Access Compliance Report Public Rights-of-Way (Curb Ramps)

Intersection ID: 11892 Main Street: BOYER_ST Cross Street: TAGGART_CREEK_RD Location: SW

ADA ID: 27B5EB6ABCD5 Ramp Type: PerpDiag Initial Pass/Fail: Fail Overall Compliance: No Severity Score: 33.75

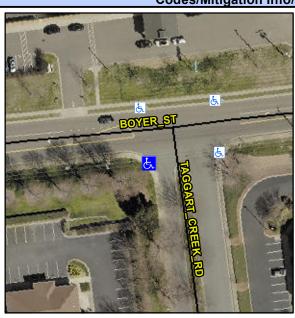
Not Found, R304.5.1, R304.2.2, R304.5.3

Field Measurements/Component Compliance					
Compliance Description		Data	Comp	liance Description	Data
N/A	Ramp Length (in)	62.0	No	Ramp Slope (%)	9.3
No	Ramp Width (in)	47.0	No	Ramp XSlope (%)	6.5
N/A	Flare Type LT	N/A	N/A	Flare Type RT	N/A
N/A	Flare Slope LT (%)	N/A	N/A	Flare Slope RT (%)	N/A
N/A	Flare Traversable LT?	N/A	N/A	Flare Traversable RT?	N/A
N/A	Landing Length (in)	N/A	N/A	DWS Provided?	N/A
N/A	Landing Width (in)	N/A	N/A	DWS Contrast?	N/A
N/A	Landing Slope (%)	N/A	N/A	DWS Length (in)	N/A
N/A	Landing X Slope (%)	N/A	N/A	DWS Full Width?	N/A
N/A	Landing Curb? (Y/N)	N/A	N/A	DWS Offset (in)	N/A
N/A	Shared Landing?	N/A			
N/A	Gutter Ponding?	N/A	N/A	Gutter Slope (%)	N/A
N/A	Gutter Lip Ht (in)	N/A	N/A	Gutter X Slope (%)	N/A
N/A	Painted X Walk1?	No	N/A	Painted X Walk2?	No
	X Walk 1 Direction	To E		X Walk 2 Direction	To N
N/A	X Walk 1 Width (in)	N/A	N/A	X Walk 2 Width (in)	N/A
	X Walk 1 Slope (%)	0.9		X Walk 2 Slope (%)	6.6

Remove & Replace Curb Ramp With Two New Directional Ramps or Equivalent.
